**DRAFT AMENDMENT C217WARR
EAST OF ABERLINE PSP
SUBMISSION ON BEHALF OF [REDACTED]
250 WANGOOM ROAD, WARRNAMBOOL (PSP PROPERTY ID: 03)**

Niche Planning Studio act on behalf of [REDACTED] the developer and landowners representative of 250 Wangoom Road, Warrnambool (**Subject Site**), otherwise known as Property 03 of the East of Aberline Precinct Structure Plan (**EoA PSP**).

Figure 1: Cross Section 5 (highlighted reference to "Vegetation Management Buffer")

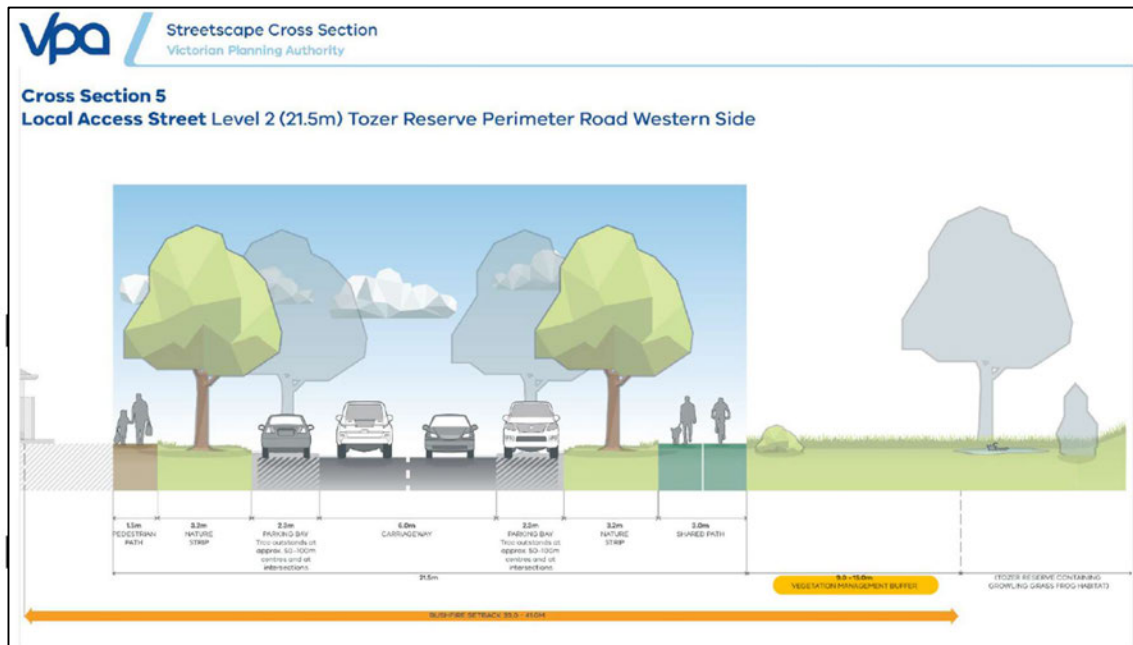
Following the EoA PSP, we note that Cross Section 5 requires a 'Vegetation Management Buffer' (VMB) adjacent to Tozer Reserve (see Figure 1 below). We understand this buffer is proposed to both provide a separation between future development and Tozer Reserve conservation land, as well as provide for a managed 'open space' for Bushfire setback purposes.

In considering this cross section, we submit that this "Vegetation Management Buffer" should be redefined and included in the EoA PSP as a Local Park. The justification for including this as a Local Park is outlined below:

- Including the VMB as a defined Local Park provides for additional opportunities for active transport opportunities, via a linear park which links LP-01 in the north with LP-02 to the south
- The proposed Local Park provides additional amenity for surrounding residents, whilst ensuring a buffer between future development and the Conservation Area (Tozers Reserve)

mit that by leaving the VMB as a 'buffer' and not an identified Local Park, creates where the land is not managed to a low threat state, and therefore Bushfire Setback requirements will essentially be extended 33-41m from the western edge of the VMB, as opposed to the Conservation Area.

Whilst we understand this is not the intention of Cross Section 5 (which shows the Bushfire Setback beginning at the western edge of Tozers Reserve) a Bushfire Practitioner must be able to satisfy themselves that the land (in this case the VMB) is being maintained to a low threat state. If not, then [REDACTED] 41m setbacks would be determined (at permit stage) to be from the edge of the road reserve, as opposed to the edge of the Conservation Reserve. By identifying the VMB as a Local Park, this removes any doubt regarding the ongoing maintenance of the buffer, and as such ensures that any bushfire setbacks are measured from the edge of Tozers Reserve as intended.

- Amend Plan 2 Place Based Plan (and other associated plans) to identify a 9m wide Local Park (LP-12) between the North-South Local Access Street, and Tozer reserve (which is currently identified in Cross Section 5 as "Vegetation Management Buffer").

[REDACTED] Amend Cross Section 5 to replace the "Vegetation Management Buffer with the Local Park (LP-12) and include the Shared Path within the Local Park.

- Amend Cross Section 5 to change the dimensions of the 'Vegetation Management Buffer' to 3-15m.
- Amend the Land Use Budget table accordingly.

Figure 3: EoA PSP Overland Flow Path (Plan 6 – Water)

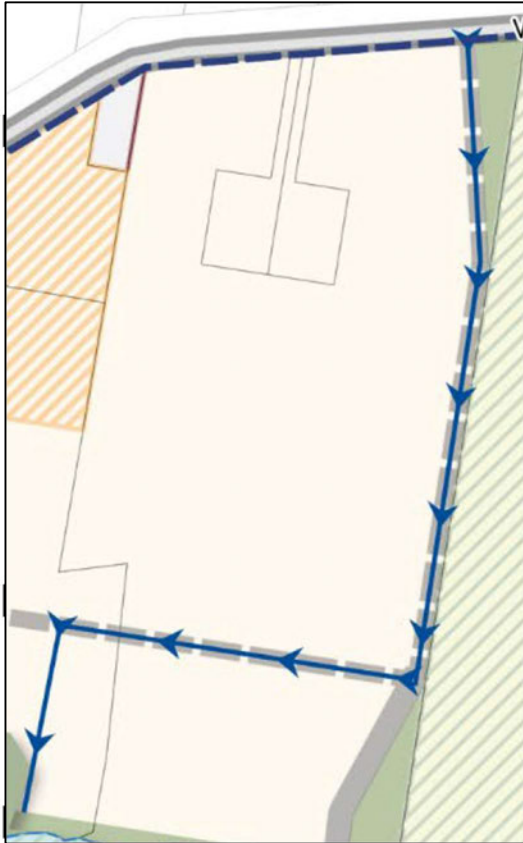
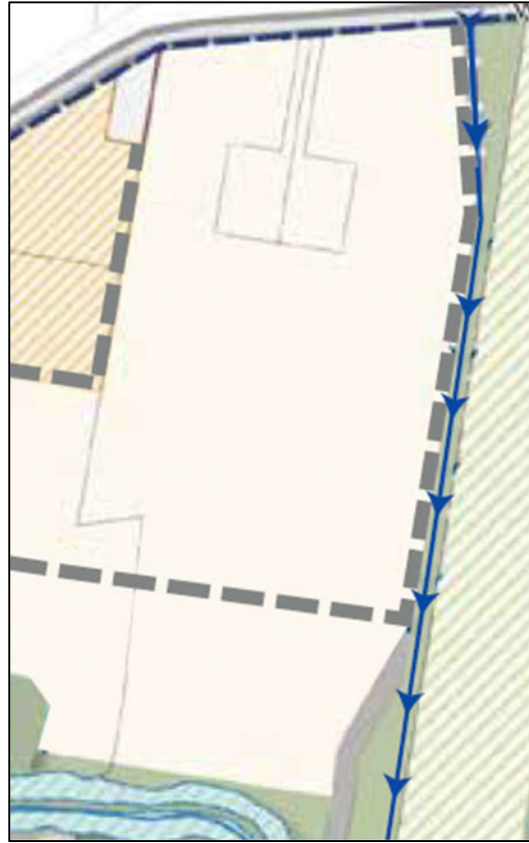
██████████ EoA PSP with regards to drainage and water management and note that there are items which are required to be addressed. One of the key items we wish to raise is shown on Plan 6 (Water). This plan shows the overland flow path heading south from ██████████ Street and then turning west and heading along the east-west local access (see snapshot below).

We submit, as per Figure 3, that the overland flow path should be redirected to head directly south, discharging into Russels Creek. Our understanding is that the overland flow path will direct 'clean' surface water (so as to not require treatment) from land to the North of the PSP through to Russell Creek and therefore does not need to be redirected to RBWL-01.

- *Revised Plan 6 (Water) to redirect the overland flow path*
- *Remove G29*
- *Remove G30*

REVISED PLAN 2 (PLACE BASED PLAN)

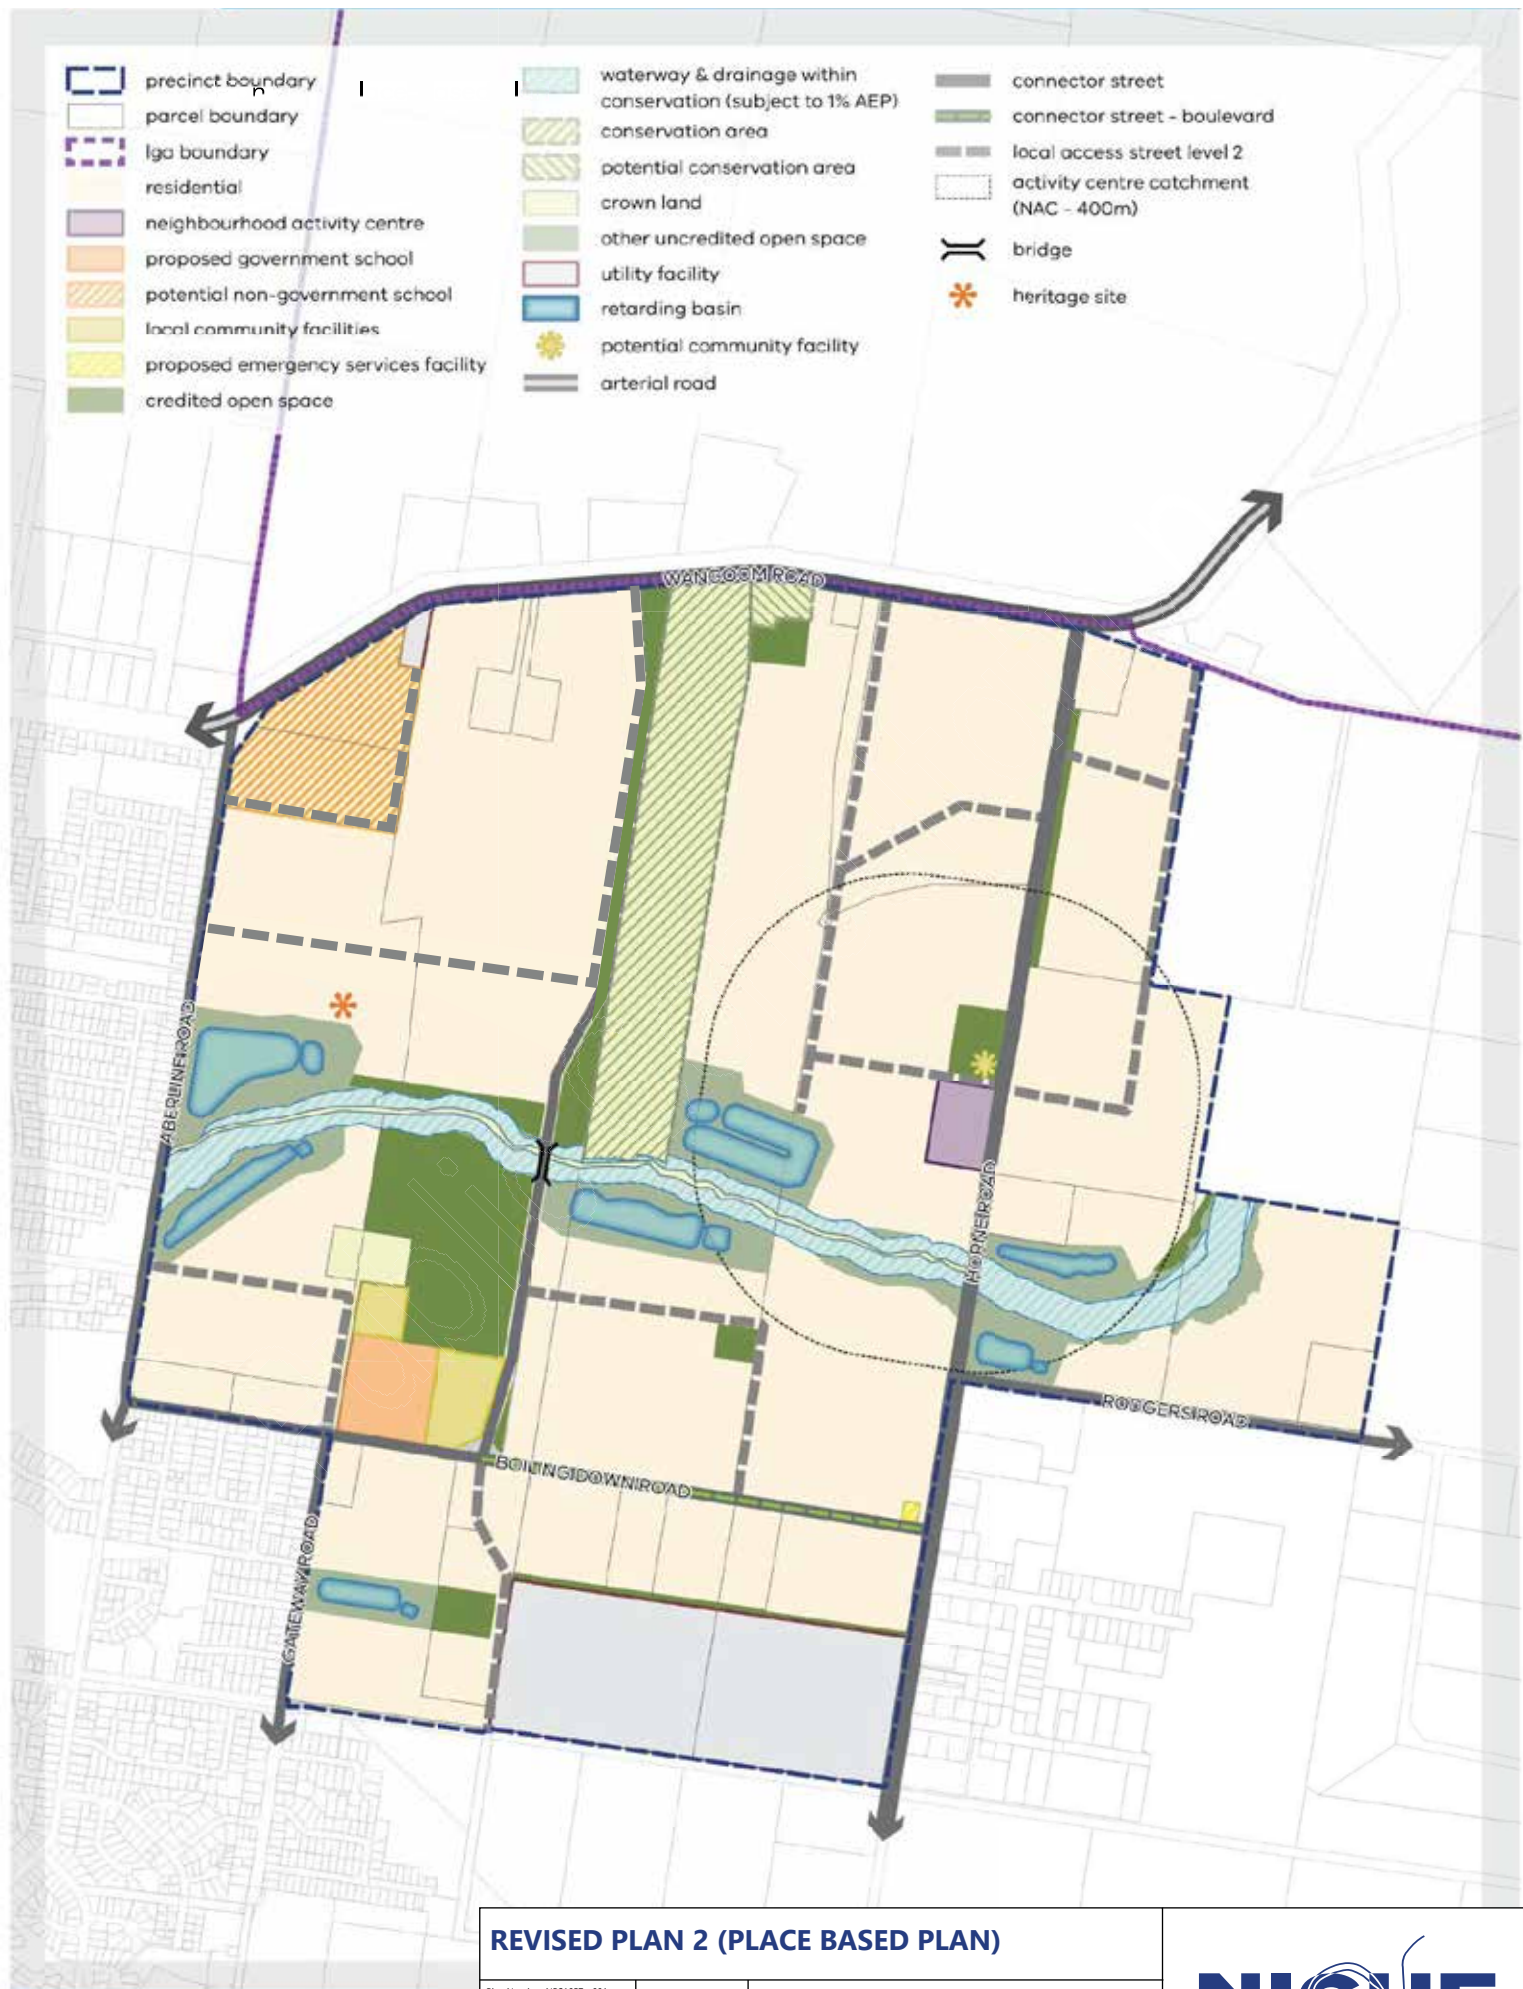
school should have a minor adjustment, to allow for the delivery of a local road boundary, within the adjoining Properties 01. & 13, as per Figure 5 (above)

- Amend Plan 2 (Place Based Plan) to show a north-south local road within the eastern property boundary of Properties 1 & 13 adjacent to the non-government school. (see Attachment 1 for further detail).
